ADDENDUM # 11

WEGO Transit and Fleet Operations Center Expansion

Request for Proposal No: RFP-22-2024-AD
Issue Date of Addendum: January 17, 2025
Proposal Submission Deadline: January 24, 2025 at 2:00 p.m. ET

ADDENDUM No.3

A0-100

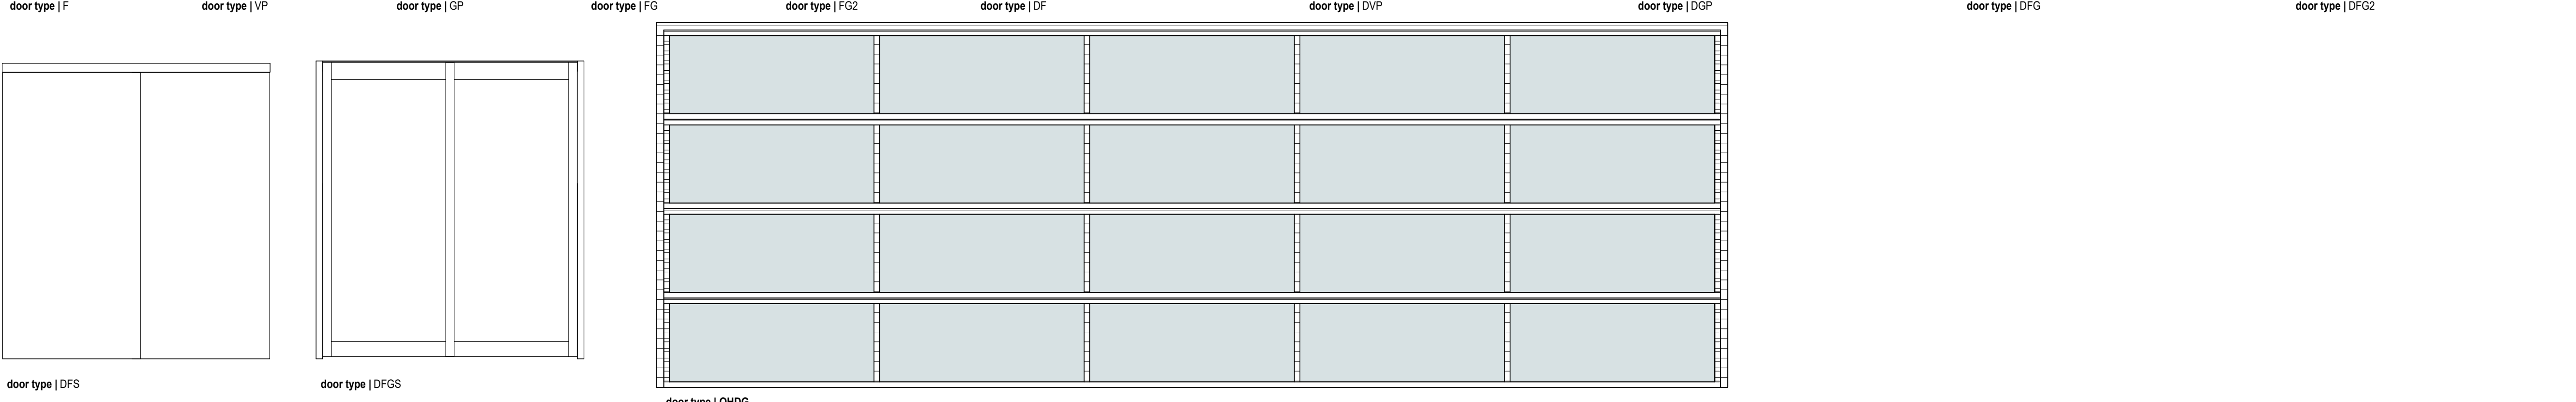
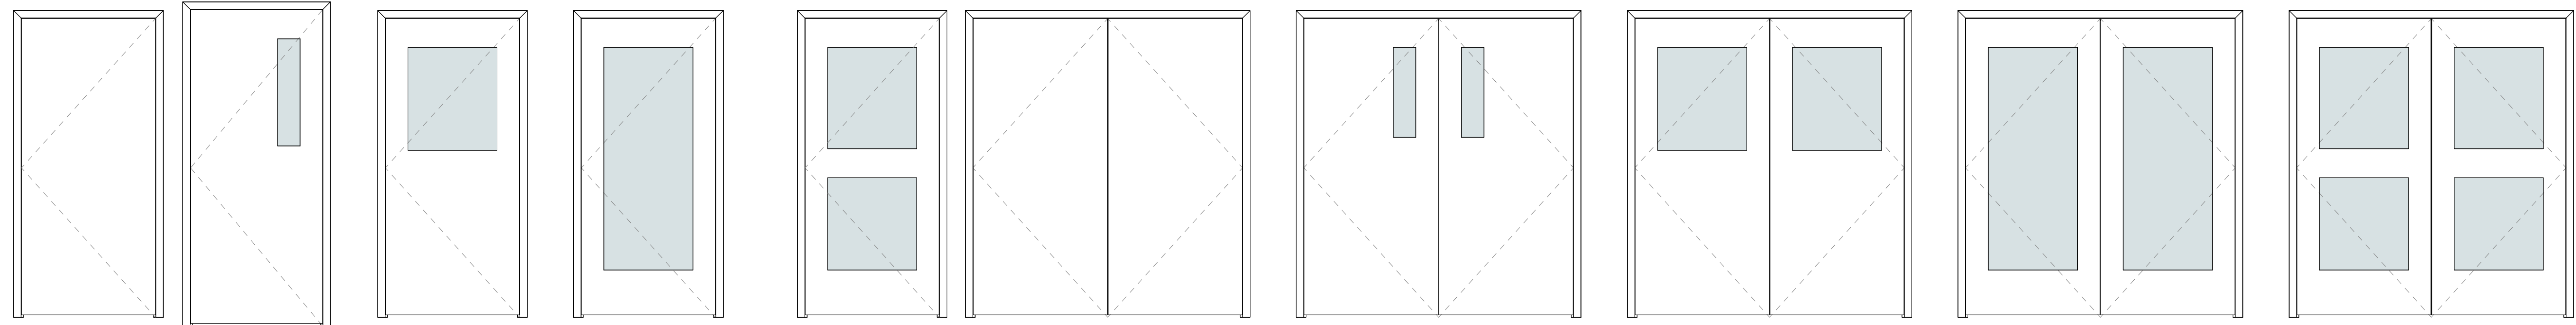
12. Ceiling type C03-A does not appear to be defined on A0-100, please clarify the ceiling assembly.

- 1.0 **Clarification: DRAWINGS – [A0-100] – [Assemblies + Legends]**
 - 1.1 [Updated Ceiling Type Legend with C03a Assembly.]
- 2.0 **Clarification: DRAWINGS – [A7-100] – [Door + Frame Schedules]**
 - 2.1 [Updated Door schedule per clarification.]
- 3.0 **Clarification: DRAWINGS – [A7-300] – [Windows & Interior Screens Schedule]**
 - 3.1 [Update Window Schedule to hollow metal frame material]
- 4.0 **Clarification: DRAWINGS – Mechanical Addendum No.2**
 - [Clarification per Bidder Questions.]

ANSWER: 3-5/8" Furring channel with 1/2" Gypsum board. Refer to Raimondo Addendum 3.

C01a	1 layer of 13 mm (1/2") gypsum board	R-VALUE	
C05a	22 mm (7/8") furring channel 16 mm (5/8") gwb - type-x 16 mm (5/8") gwb - type-x	R-VALUE	1 HR
SAT1	Typ. all corridors unless noted 2x4 scored tile selection by owner	R-VALUE	
C03a	93 mm (3-5/8") furring channel 13 mm (1/2") gypsum board finish	R-VALUE	1 HR

A7-100

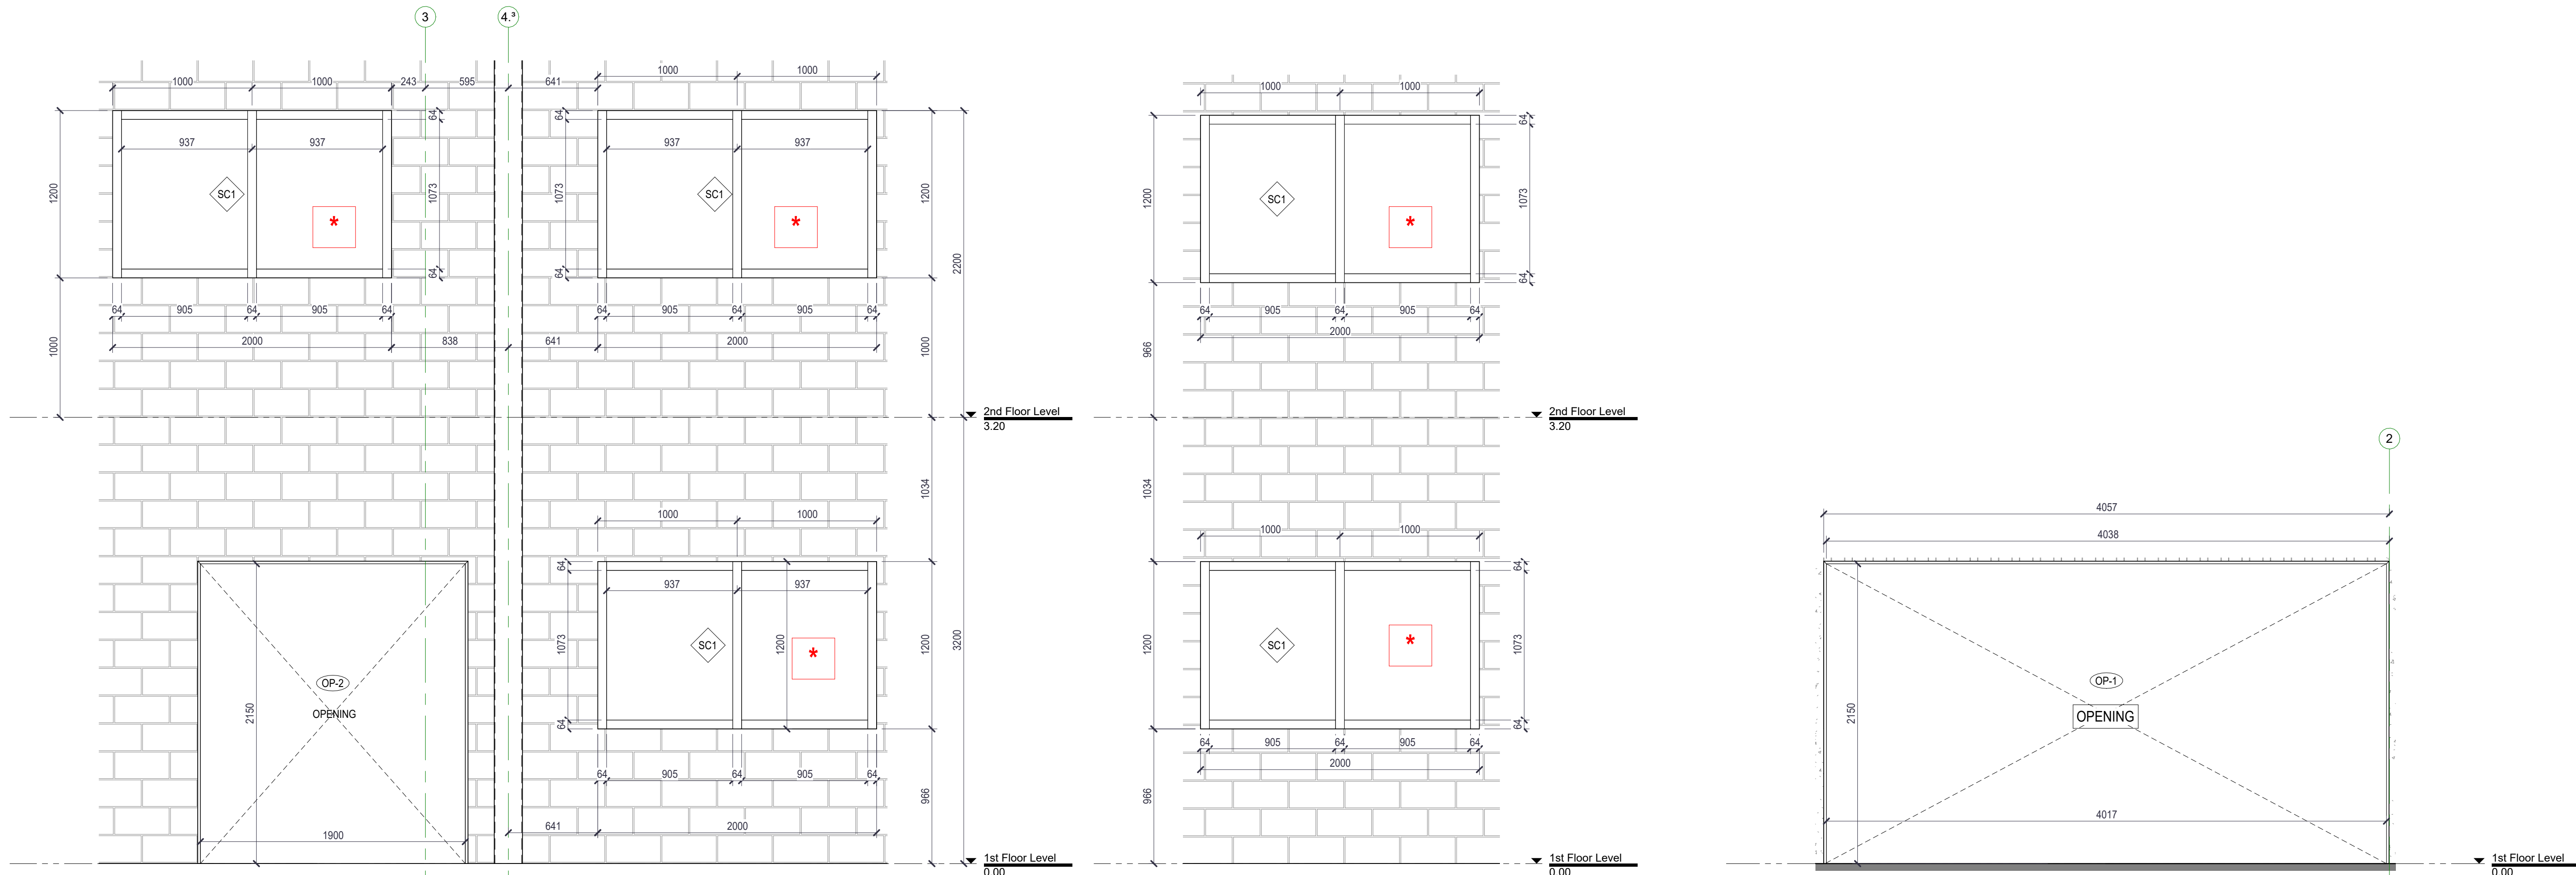
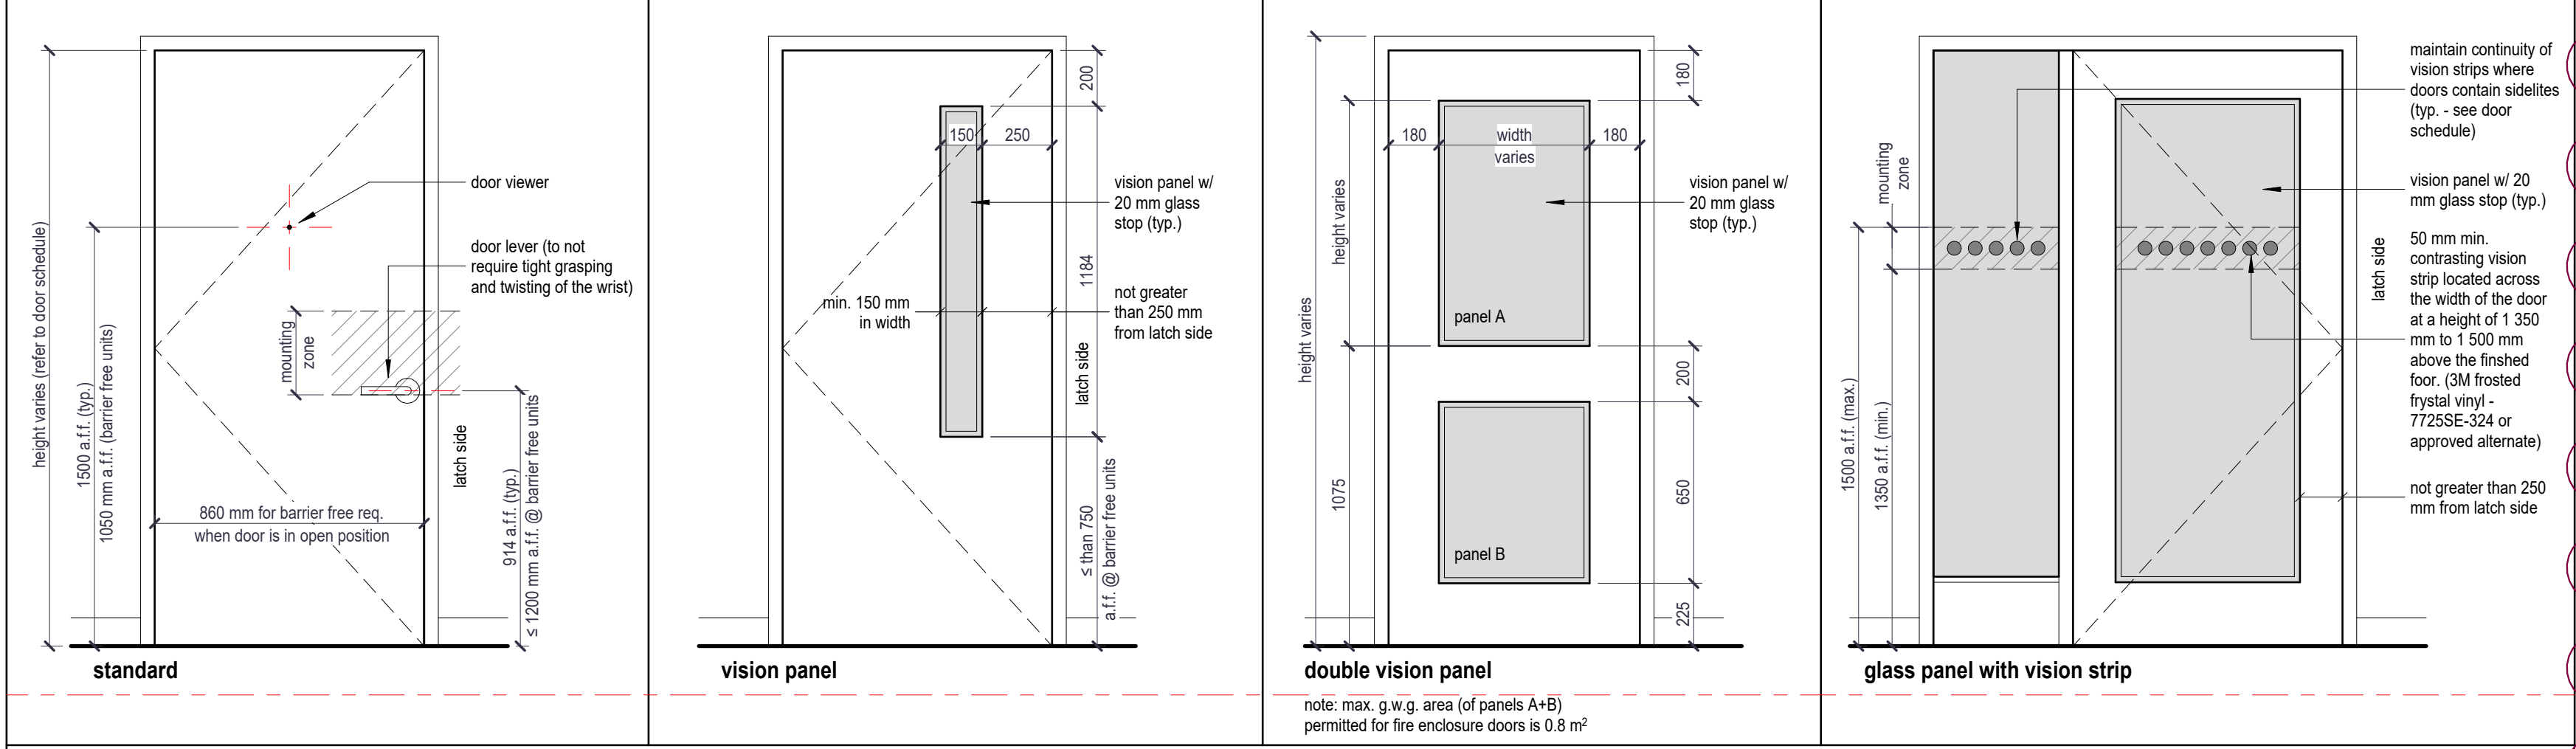
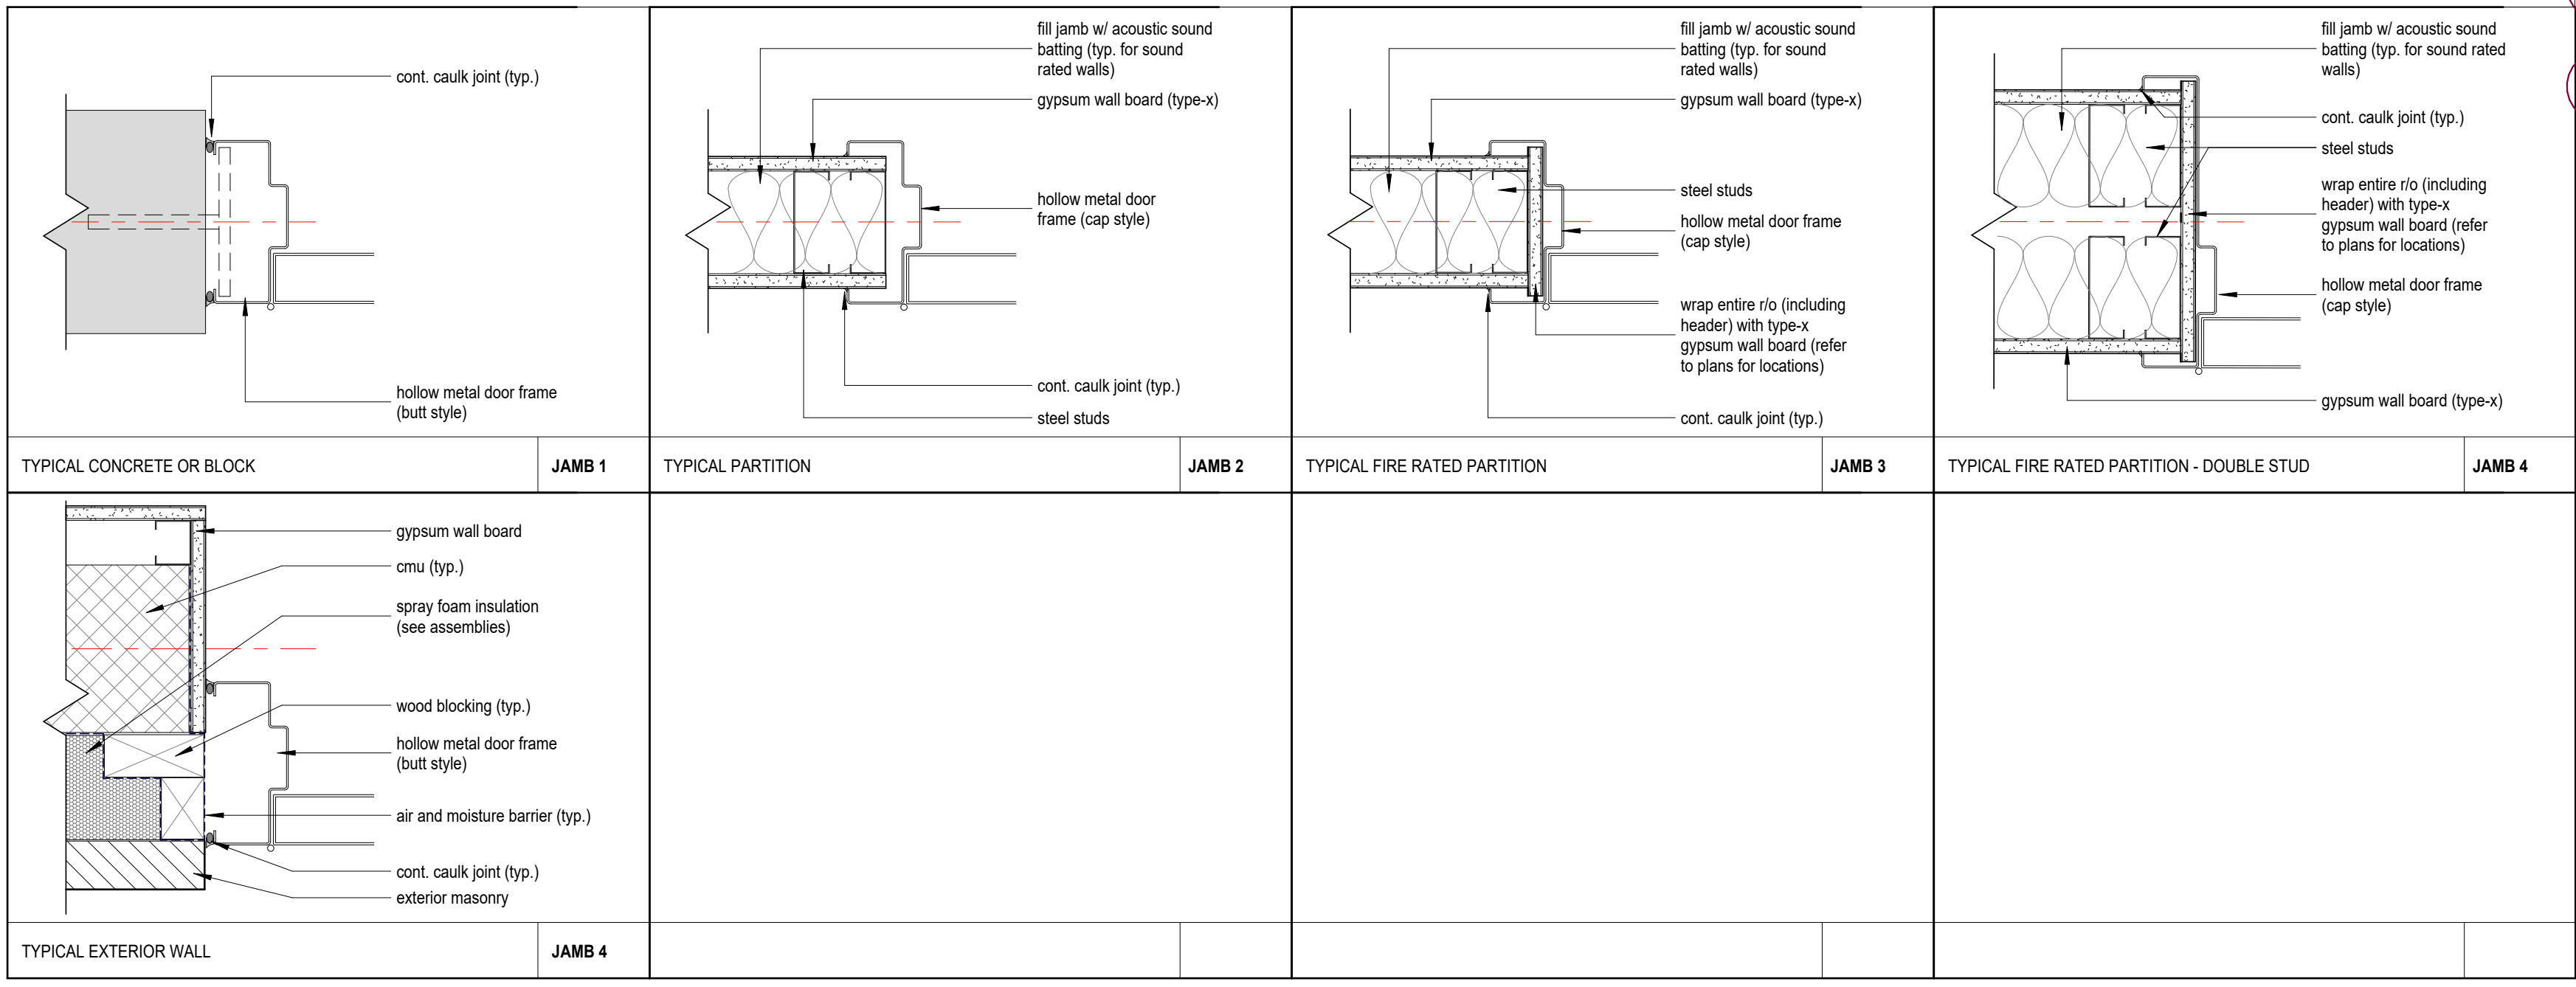
1. Could you please clarify the door schedule (drawing A7-100) on the WEGO transit project.

2. There are 8 doors (D-006, 008, 009, 010, EX-D01, EX-D02, EX-D03, EX-D04) that are identified as glazed doors (types VP, DFG, DVP, FG2) but the corresponding glazing type for these doors is ‘n/a’. Please confirm if glazing is required for these doors, and if so what type

3. One door (D-011) is identified as 45 fire rated but 6mm tempered glazing is called up. Please confirm if these doors are fire rated and if fire rated glazing is required

4. Should door D-010 be fire rated, and if so is door type FG2 correct?

ANSWER: Refer to Raimondo Addendum 3 for more information. (attached to this Addendum)

ANSWER: Glazing is required for the doors. 20mm vision panel typical. Refer to Raimondo Addendum 3. (attached to this Addendum)

ANSWER: Doors are fire rated 45 Min. and glazing is fire rated. Refer to Raimondo Addendum 3. (attached to this Addendum)

ANSWER: Door to be fire rated 45 Min. Door type has been revised to F type, no glazing. Refer to Raimondo Addendum 3. (attached to this Addendum)
